ASSESSMENT REPORT

Section 75W Modification

Visy Smithfield Boiler Reinstatement (DA 13/94 MOD 7)

Figure 3: Indicative boiler layout for Scenario 1 and 2

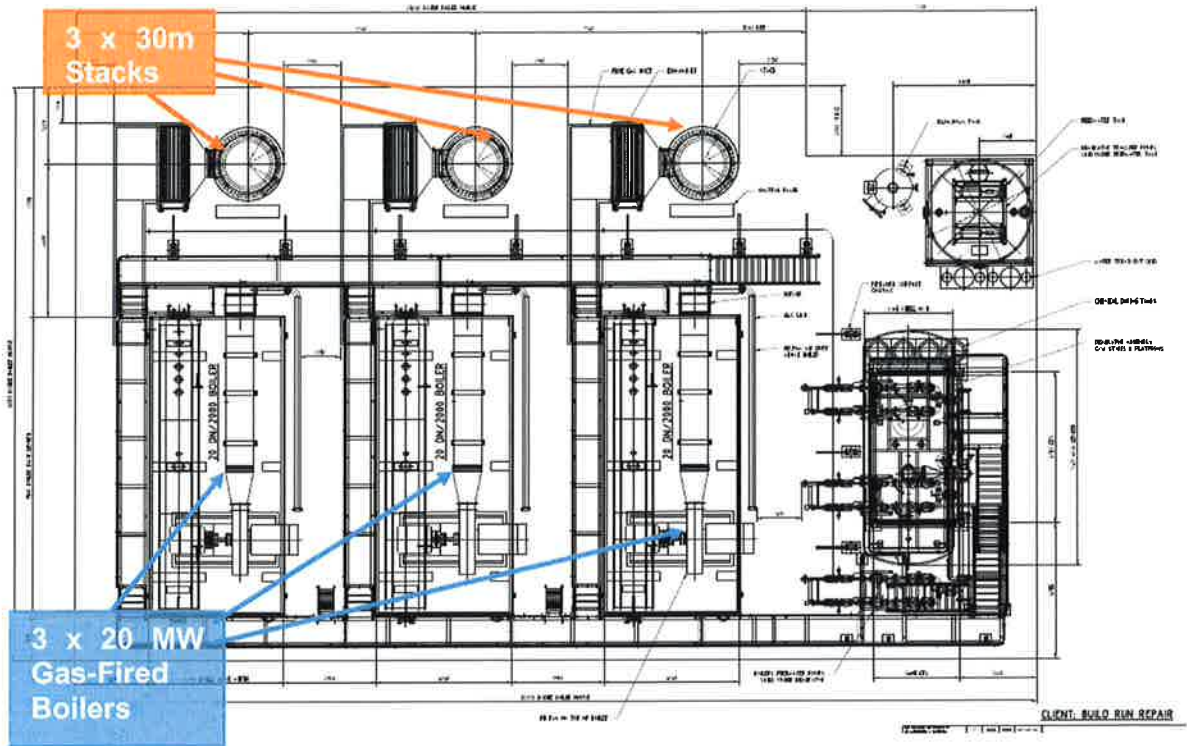
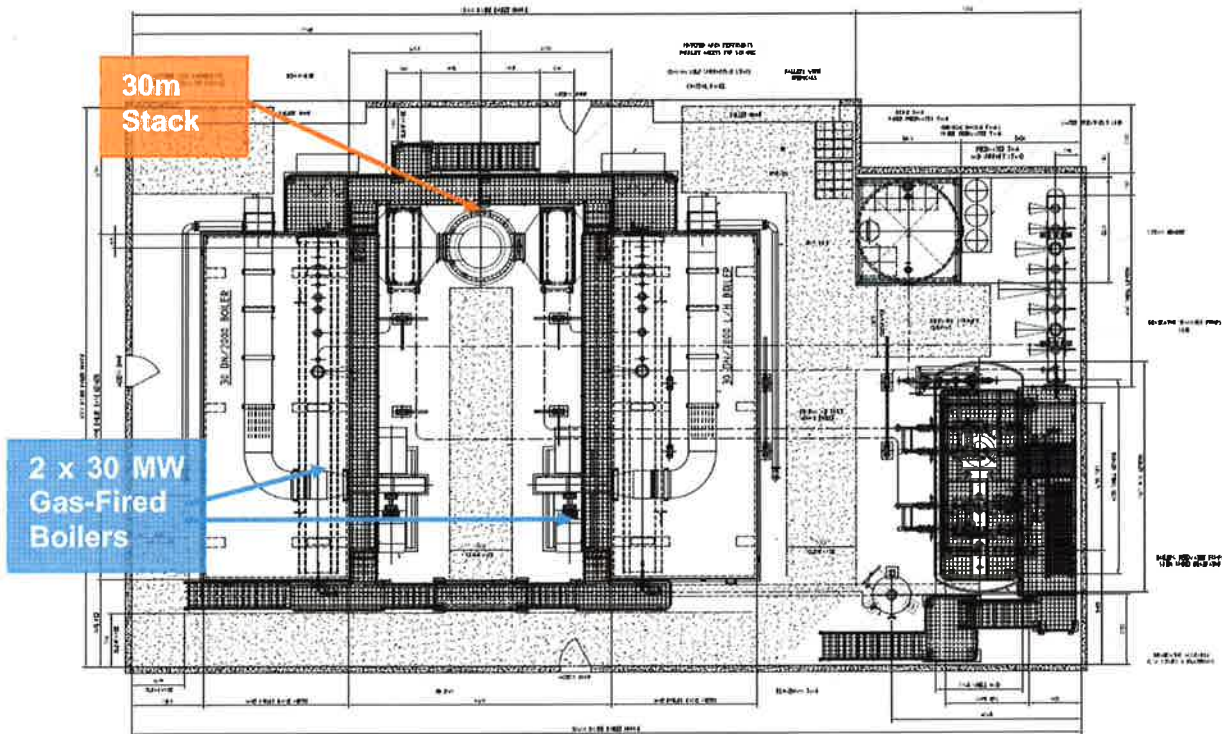
The boiler configuration for Scenario 2 is comprised of two gas boilers with one single 30m stack. The EA concluded that the visual impacts for Scenario 2 would be minimal but noted that having one stack would be less aesthetically intrusive than three stacks under Scenario 1. As with Scenario 1, visible emissions from the stack would be minimal.

The Department considers that the visual impacts to nearby receivers would be negligible given the height of the stack and the reduction in the number of stacks from three to one. The Department's assessment concludes that the visual impact of Scenario 2 would be insignificant and that no additional conditions are required.

Figure 4: Nearest sensitive residential receivers (R1 to R11)

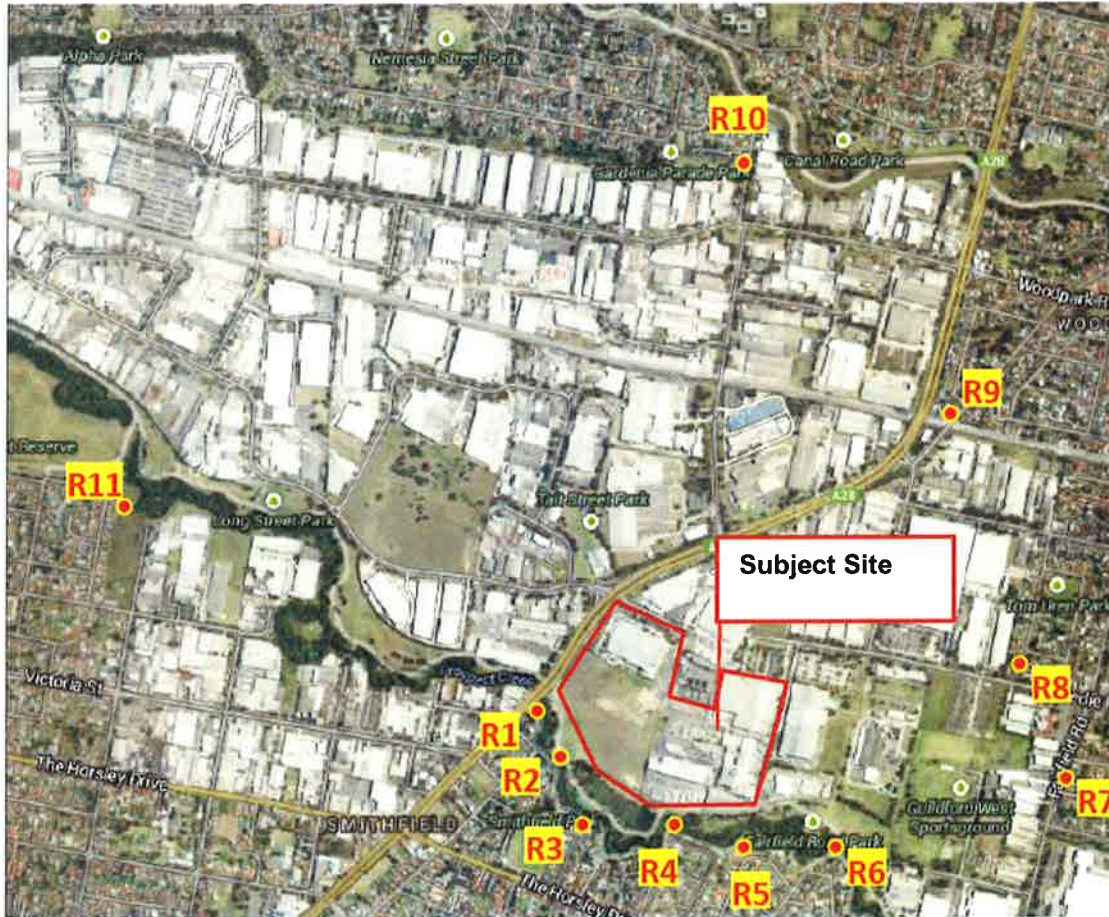
The EA prepared in support of the modification request included two separate noise impact assessments (NIA) which modelled the potential operational noise impacts of Boiler Scenario 1 and 2, respectively. The noisy components of both boiler scenarios include the fan casings, stack outlet, in-ducts and feedwater pumps.

The EA stated that if either boiler scenario could be shown to operate at 10 dB(A) or more below the existing noise criteria for the site, it would not increase the overall noise levels from the site. The Department considers that this approach is acceptable as this will ensure that in operation, noise from the gas-fired boilers would not contribute to an increase in noise from the entire facility at the nearest residential receivers.

The proposed noise criteria for the gas-fired boilers in order to manage any potential increase in overall noise impacts from the site are given in **Table 2** (i.e 10 dB(A) below the existing consent and EPL noise levels for the site). The NIA stated that a 10 dB(A) reduction in the noise coming from the gas-fired boilers could be achieved using noise controls including a silencer at the stack inlet and noise enclosures for the casing.

The NIA predicted that in a worst case scenario, noise levels for Boiler Scenario 1 and 2 (with noise controls in place) would be between 15 dB(A) to 31 dB(A) and 15 dB(A) to 30 dB(A) during day-time, evening and night-time periods at the nearest sensitive receivers. These noise levels are predicted to be at least 10 dB(A) or more below the noise limits outlined in **Table 2**. As such, the Applicant has committed to installing noise controls for the preferred boiler scenario to ensure a minimum 10 dB(A) reduction in noise levels.

Council raised no concerns with the NIAs. The EPA required the Applicant to include an assessment of wind effects. This issue was subsequently addressed in a revised assessment to the satisfaction of the EPA. Based on this revised assessment, the EPA stated it was satisfied that overall noise outputs from the facility would not increase from the operation of the boilers (under either Scenario 1 or 2).

Notwithstanding, the EPA considered that the modification request had not considered opportunities to address the issue of overall noise emissions from the site. In this event, it is likely that the EPA would impose a Pollution Reduction Program (PRP) on the EPL to progressively reduce noise emissions in the event that noise complaints are received.

The Department concurs with the EPA and considers that the operation of the preferred gas-fired boiler design at 10 dB(A) below the noise criteria would not contribute significantly to higher noise levels from the site. The Department understands that the EPA may implement a PRP for the site in the future to address the current operational noise issues at the site. In addition, if noise reductions from the overall site are achieved in the future, the Department is satisfied that the gas-fired boilers would not impede the Applicant's ability to progressively lower noise levels from existing plant and equipment to achieve lower overall noise levels at the site.

The Department is satisfied that the noise impacts associated with either boiler scenario (1 or 2) would be insignificant, provided the Applicant complies with the following recommended modifying conditions:

- the preferred boiler option shall be designed so that it is at least 10 dB(A) below current noise limits;
- the preferred boiler option shall incorporate a silencer and noise enclosures;
- within three months of commissioning the preferred boiler option, the Applicant is required to demonstrate compliance with the existing noise limits for the facility;
- if compliance is not demonstrated, then the Applicant must undertake works to ensure that overall noise levels from the site are reduced by at least the amount of the non-compliance; and
- the noise management plan shall be updated to include the reasonable and feasible noise mitigation measures to minimise noise from the gas-fired boilers.

Figure 5: (top) looking east to the site from the southern boundary of the facility and (bottom) view of the site 1.6km north-northeast of the facility on Cumberland Highway

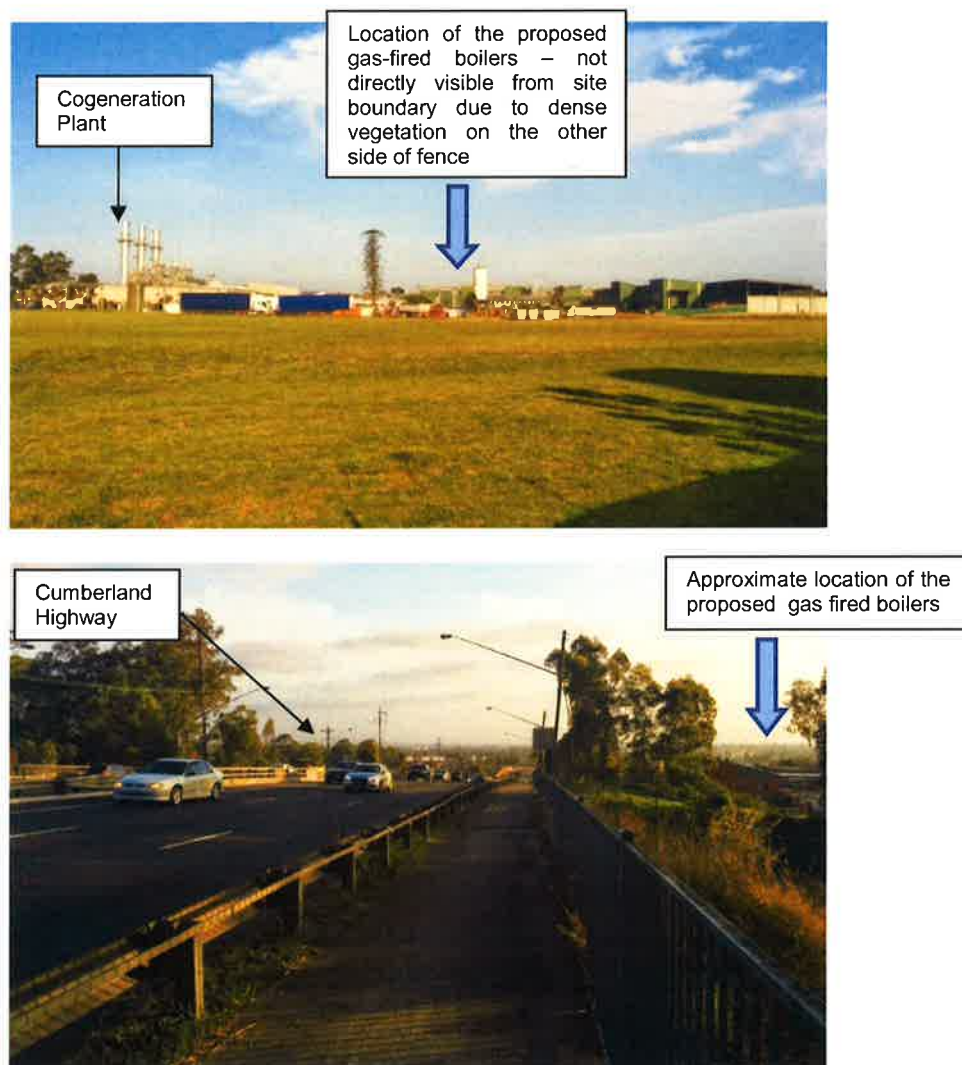
The boiler configuration for Scenario 1 comprises of three gas-fired boilers and three emission stacks with a height of 30m each. The EA notes that the boilers would be located at the centre of the site and the stacks may be visible when travelling along the Cumberland Highway for a distance of up to 1.6 kilometres north-northeast of the site as shown in **Figure 5**.

The Applicant considers that potential impacts on visual amenity at the closest sensitive receivers to the south of the site would be insignificant due to dense vegetation surrounding the site and existing surrounding industrial buildings. In addition, the Applicant also

Council did not raise any issues in relation to visual impacts. The Department has reviewed the site photos and aerial maps of the site and agrees with the Applicant that the visual impacts to nearby sensitive receivers would be minimal, given that the gas boilers would be located away from any nearby receivers in the centre of the site and would be surrounded by existing industrial buildings. The Department also understands that the original gas fired boilers approved as part of the original development also included stacks of a similar height to the stacks proposed for the modification.

The Department considers that the stacks would not be visible from the closest residential receivers south of the site due to mature and dense vegetation surrounding the site and Prospect Creek. However, the stacks may be visible 1.6km away on the Cumberland Highway but the Department considers that the visual impacts would be minor as the surrounding environment is already built up and vehicles travelling on the Cumberland Highway would only be temporarily impacted.

The Department's assessment concludes that the visual impact of Boiler Scenario 1 would be insignificant and that no additional conditions would be required.
